## STAFF RECOMMENDATION 3700 Central Avenue March 16, 2016

**Application:** Demolition – outbuilding; New construction - addition  
**District:** Richland-West End Neighborhood Conservation Zoning Overlay  
**Council District:** 24  
**Map and Parcel Number:** 10409001400  
**Applicant:** Brittney Mount, Architect  
**Project Lead:** Sean Alexander, sean.alexander@nashville.gov

**Description of Project:** The applicant proposes to enlarge the house with a side addition which will include a basement-level garage accessed from the side street.

# Site Layout Plan

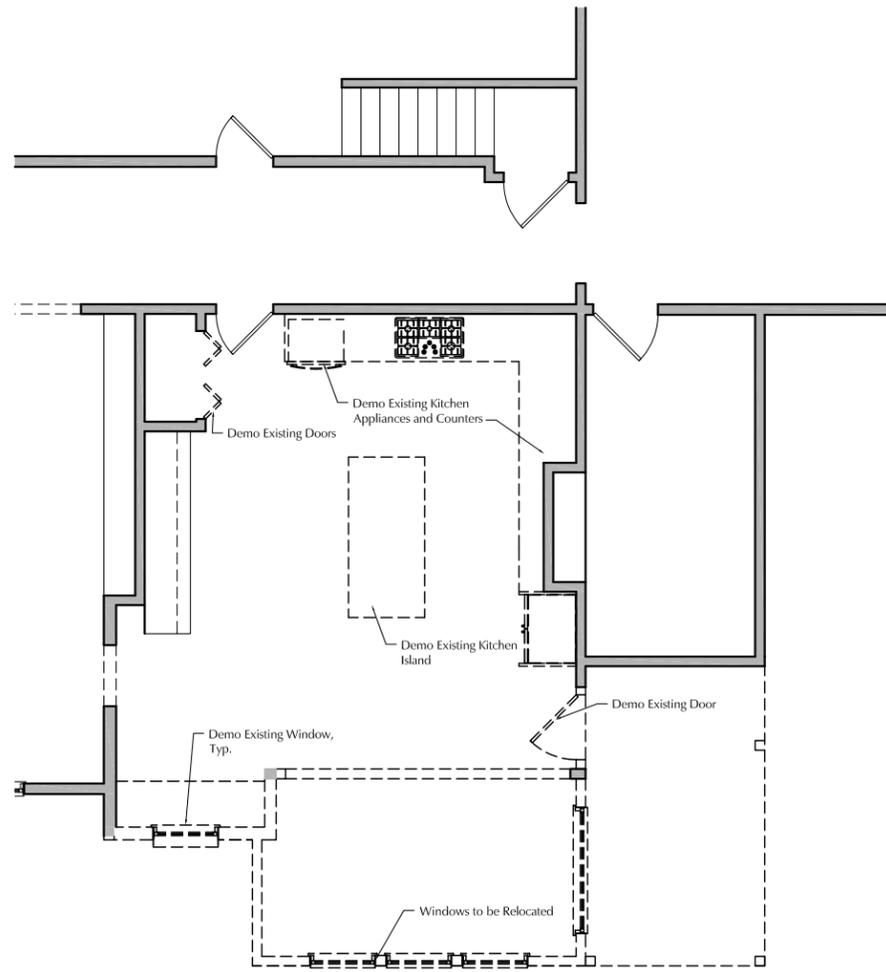
Setback & Rhythm of Spacing: As the addition steps out to the right of the silhouette of the historic house, it will have a shorter setback than the existing house. The outer wall of the addition will have a ten foot (10') side setback, and the garage will be seventeen feet, six inches (17'-6") from the property line. The standard setback requirement for houses is ten feet (10'), but garages are required to be twenty feet (20') from a side street. In this location, an additional two foot, six inch (2'-6") buffer to sidewalk and an additional five foot (5') buffer from the curb give the proposed addition the appearance of a setback greater than twenty-five feet (25'). This setback would be compatible with the surrounding context, as Craighead Avenue is a wide street where several historic garages were accessed from the street. For this reason, Staff finds that the proposed setbacks for the project meet section II.B.1.c of the design guidelines.

Appurtenances & Utilities: The two existing driveways will be removed and a new pair of driveways sharing a single curb cut will take their place. The location of the HVAC and other utilities was not noted. Staff asks that the HVAC be located on the rear façade, or on a side façade beyond the midpoint of the house, and that the project otherwise meets section II.B.1.i of the design guidelines.

2 South Elevation  
 Scale: 1/8" = 1'-0"

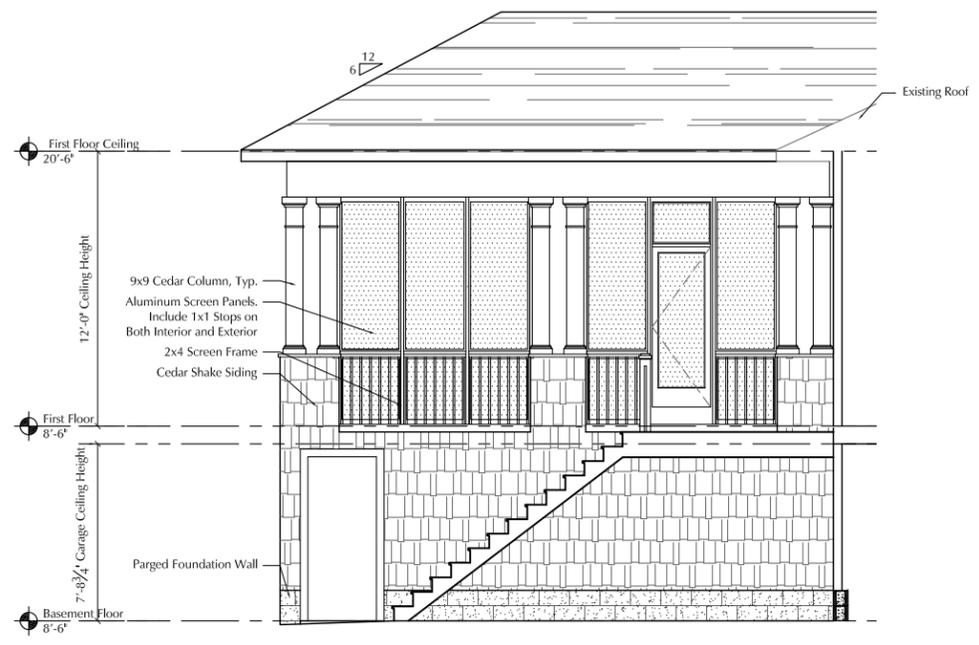
Design: The character of the addition will be very similar to that of the historic house, with matching roof form and pitch, matching window proportions, and matching exterior cladding. The lower height and open porch create a massing that is visually subordinate to the historic home. Staff finds the design of the addition will meet sections II.B.2.a and II.B.2.e of the design guidelines.

Roof form: The addition will have a side-gabled component and a hipped component facing rear, matching the gable and hipped forms of the historic house. The pitch of the new roofs will be 6:12, also matching the historic house. Staff finds that the project meets section II.B.1.e of the design guidelines.
